Subject: AP1000 Response to Requests for Additional Information on Containment Vessel External Pressure Analysis - RAI-SRP-3.8.6-SEB1-01 R1, RAI-SRP6.2.1.1-SPCV-07 R1, and RAI-TR09-008 R3

# AP1000 TECHNICAL REPORT REVIEW

RAI Response Number: RAI-SRP6.2.1.1-SPCV-07

RAI Response Number: RAI-SRP-3.8.6-SEB1-01

Figure D-1

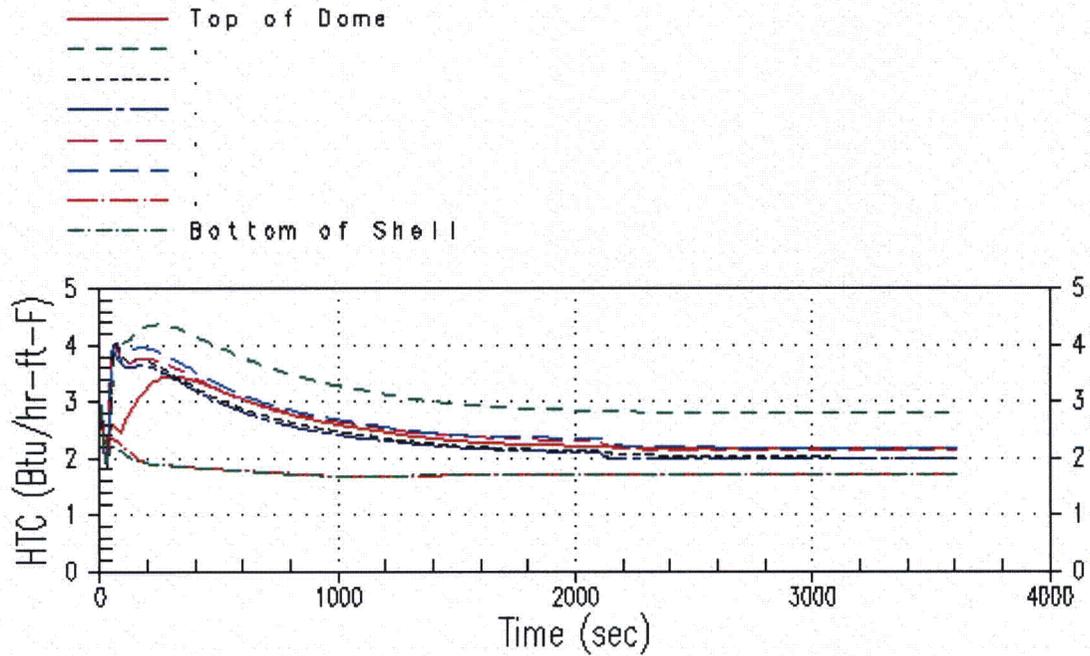
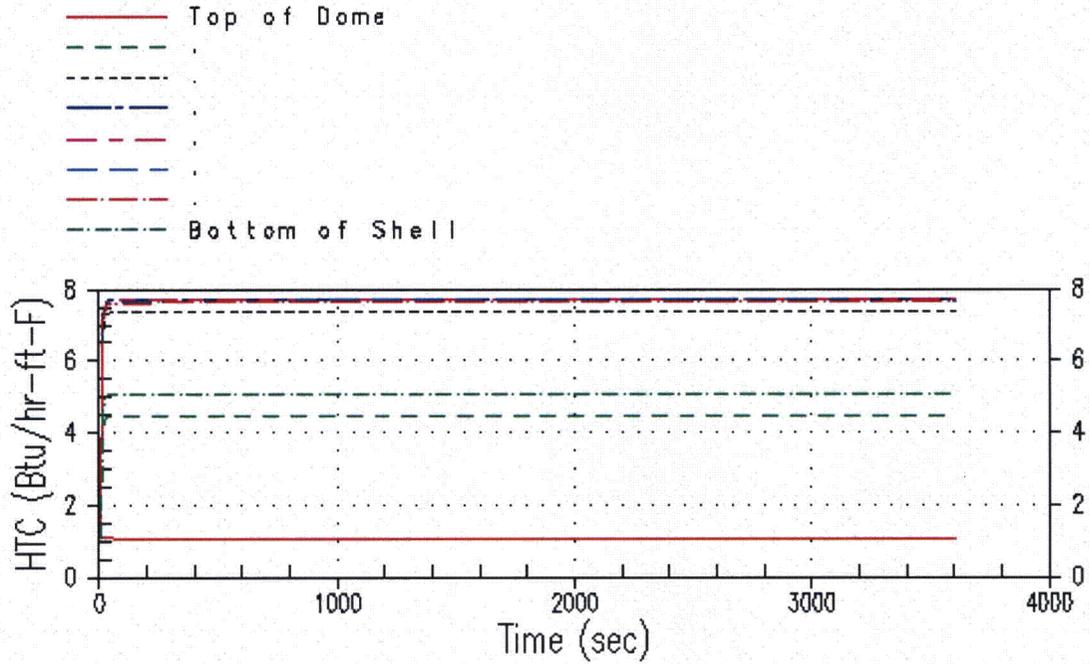
- d) In response to RAI-SRP6.2.1.1-SPCV-01 and -03, Westinghouse provided values calculated by WGOTHIC for the heat transfer coefficients of the containment shell, baffle, and shield building. Explain how these were derived (specific time point and WGOTHIC conductor) and why they differ from the heat transfer coefficients reported in the referenced calc notes (where at 3600 sec, h-outside containment shell =5.2 B/hr-ft<sup>2</sup>-°F and h-inside containment shell =1.6 B/hr-ft<sup>2</sup>-°F).

- c) The DCD figure 6.2.1.1-11 time scale is in error and should be corrected. See DCD revisions section below.
- d) The heat-transfer coefficients provided in the RAI responses were taken from different thermal conductors than the heat-transfer coefficients plotted in the calcnote. The heat transfer coefficients calculated by W Gothic for one "stack" of shell thermal conductors (PCS shell from the dome to the operating deck) from the steady-state run are presented in Table D-1. The heat transfer coefficients calculated by W Gothic for one stack during the transient are provided in Figures D-1 and D-2.

Table D-1  
Heat Transfer Coefficients from the Steady State Run

Location	Inside HTC Btu/hr-ft <sup>2</sup> -°F	Outside HTC Btu/hr-ft <sup>2</sup> -°F
Top of Dome	1.8	1.1
-	3.5	4.5
-	2.8	7.4
-	2.9	7.8
-	3.4	7.8
-	1.9	7.7

Figure E-1

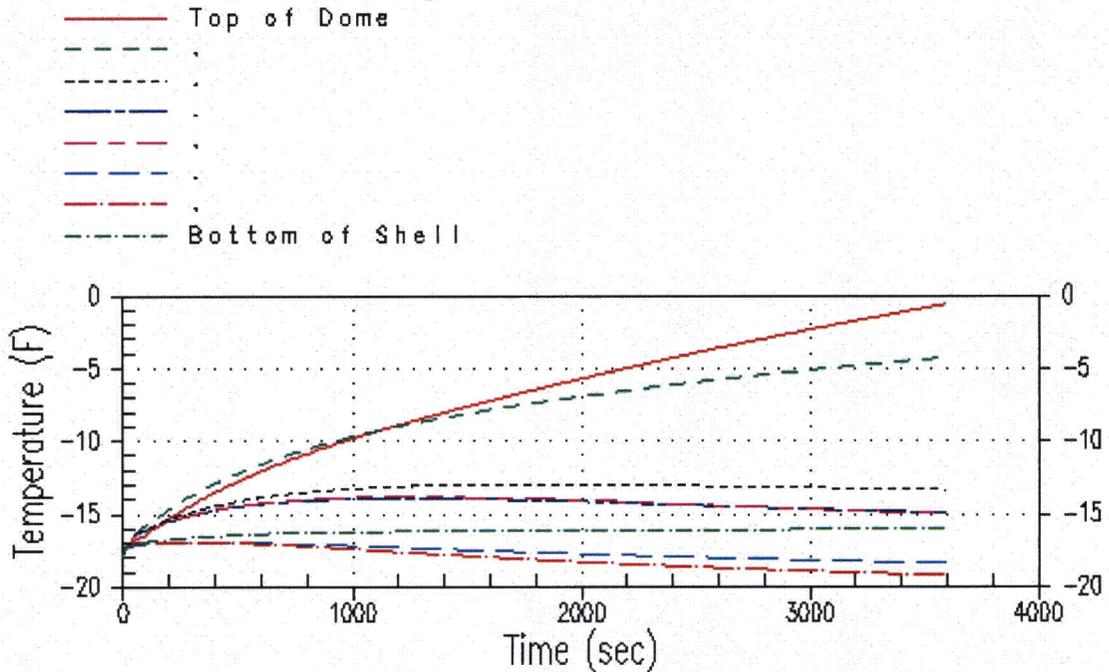
- e) Although the referenced calc-notes state that the containment shell temperature was initially set to -18°F for the second part of the analysis (actuation of fan coolers after steady state operation at low temperature), the WGOTHIC model included in the Appendix has the shell conductors set to 69°F. Please provide a plot of the containment shell temperature versus time for this transient.

- e) The containment shell initial temperatures were appropriately set to  $-18^{\circ}\text{F}$  in the transient WGOthic run of APP-MV50-Z0C-020. The initial temperature was determined from a conservative estimate of the average temperature of the shell in the steady-state run. The temperature response of one PCS "stack" during the transient is provided in Figure E-1.

Figure F-1

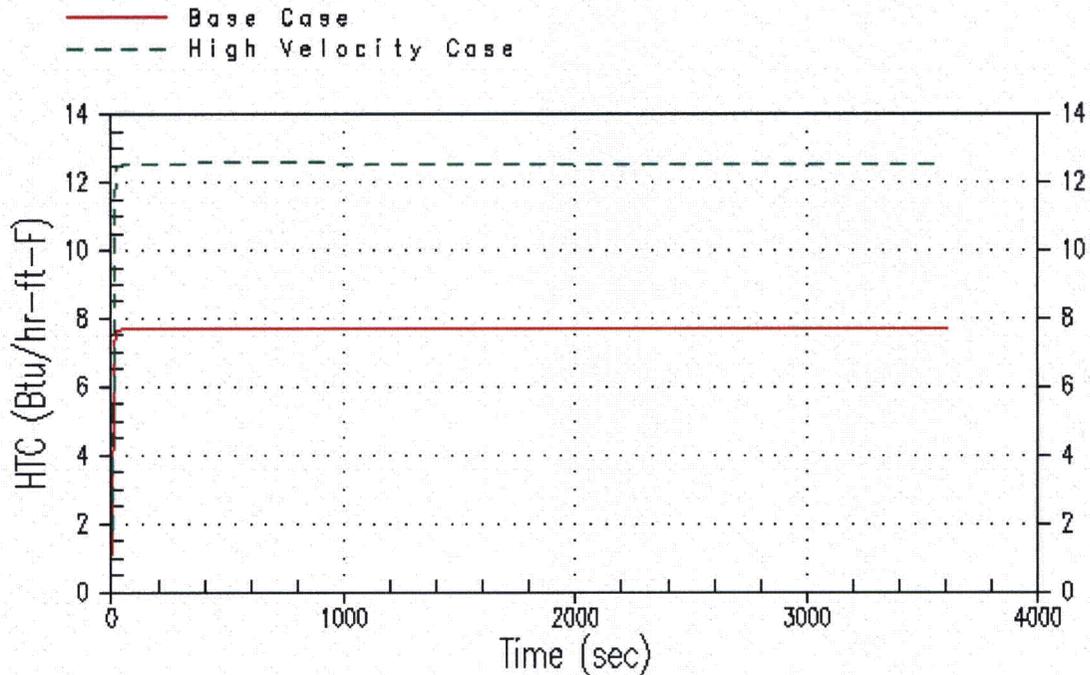
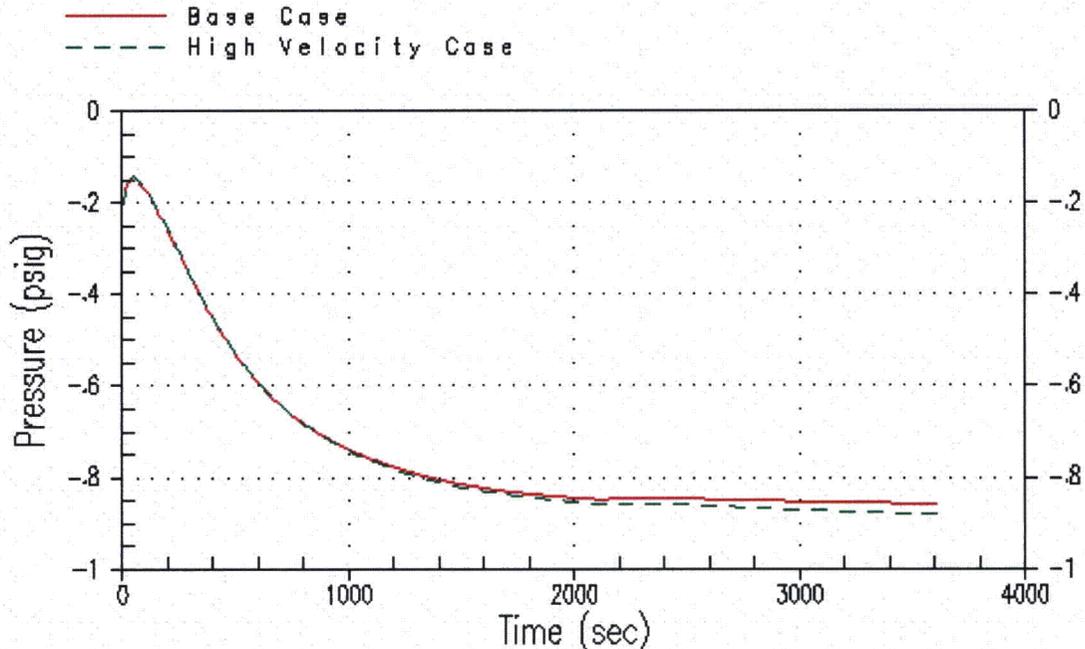
- f) In response to RAI SRP 6.2.1.1-SPCV-04, Westinghouse states that the changes to the shield building air inlets make the air velocity in the annulus less dependent on external wind speed. In the original design, the assumed 48 mph wind speed was modeled with a 25 mph annulus velocity. For the new shield building design, describe how annulus velocity was modeled and how this correlates to a 48 mph wind speed.

- f) The wind-induced annulus velocity does not have a significant impact on the calculation with respect to the annulus velocity induced by the gas-density difference in the PCS. In the APP-MV50-Z0C-020 analysis, WGOthic calculates the velocity through the annulus, which is 25 ft/s (17 mph), based on density differences. A sensitivity analysis was run increasing the heat-transfer coefficients in the PCS annulus by 1.62 in the transient pressure case. The Nussult number is a function of the velocity (Reynold's number) raised to the 0.8 power, so the resulting heat-transfer coefficient corresponds to an annulus velocity of 36.8 ft/s (25 mph). The WGOthic heat-transfer coefficients on the outer shell surface increase as shown in Figure F-1. The impact on the peak external pressure is 0.024 psi (Figure F-2), which is a 3% increase in the external pressure.

Replace the current DCD Rev. 17 Figure 6.2.1.1-11 (shown here)

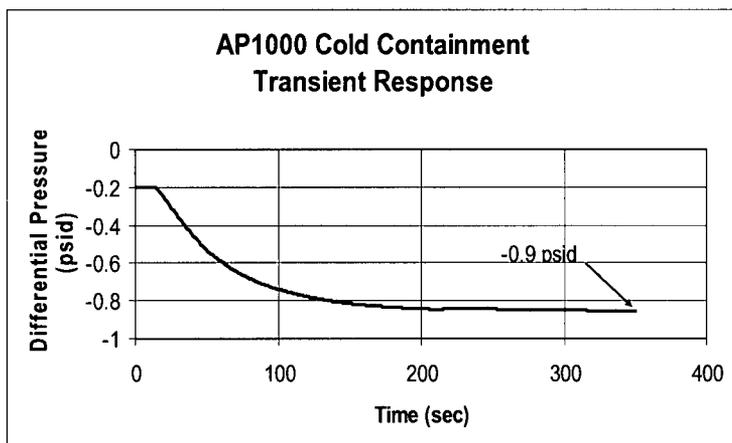
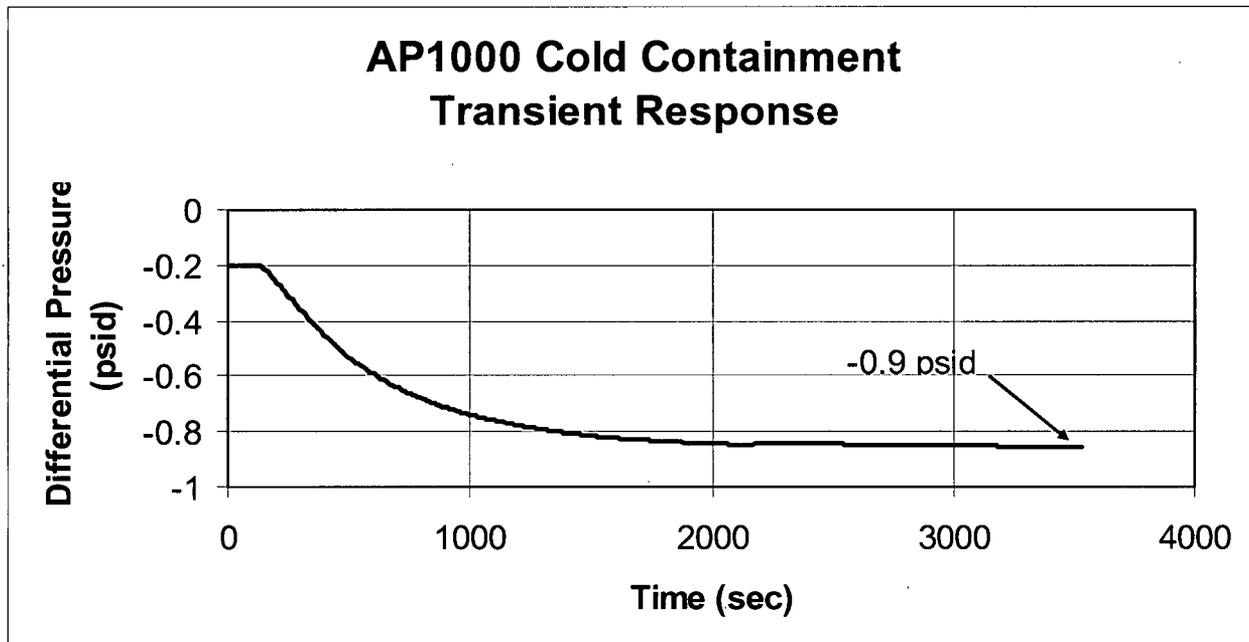
- c) There is a 10x difference in time scale between DCD Figure 6.2.1.1-11 and the associated data points from Appendix E of the referenced calc notes. Please resolve the discrepancy. If the scale in the DCD Figure is correct, justify why analysis ended after 6 minutes.

With this version:

Figure 6.2.1.1-11 AP1000 External Pressure Analysis Containment Pressure vs. Time

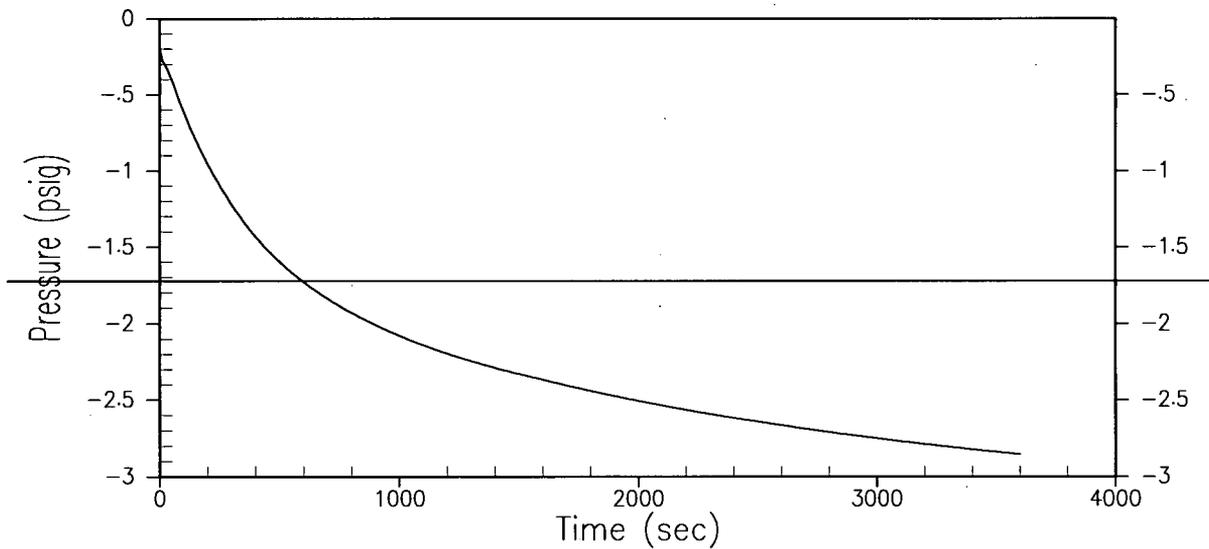
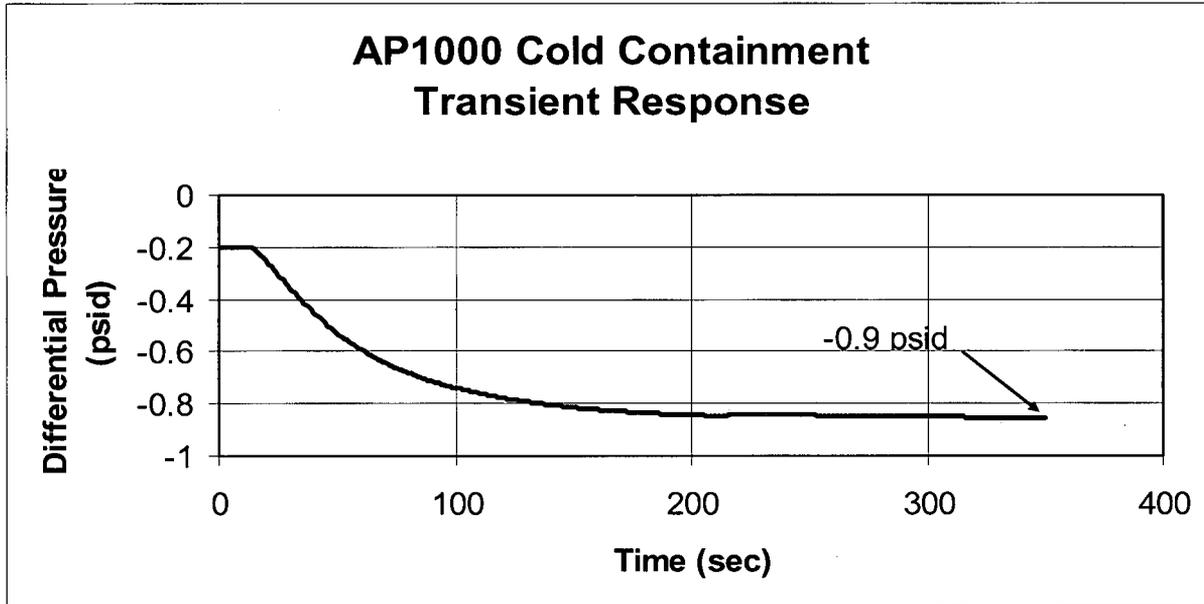
Resolution of RAI-TR09-008 is tied to the resolution of RAI-SRP6.2.1.1-SPCV-07. Explain inconsistencies in DCD Section 3.8.2.6, Table 3.8.3-1, and Tech Spec Bases B 3.6.4.

For consistency with Figure 6.2.1.1-11, the words ‘at one hour’ were deleted from the text in section 6.2.1.1.4 of the DCD, Revision 16. This change and all other DCD changes shown below were incorporated in Revision 5 of APP-GW-GLR-134 (Technical Report 134).
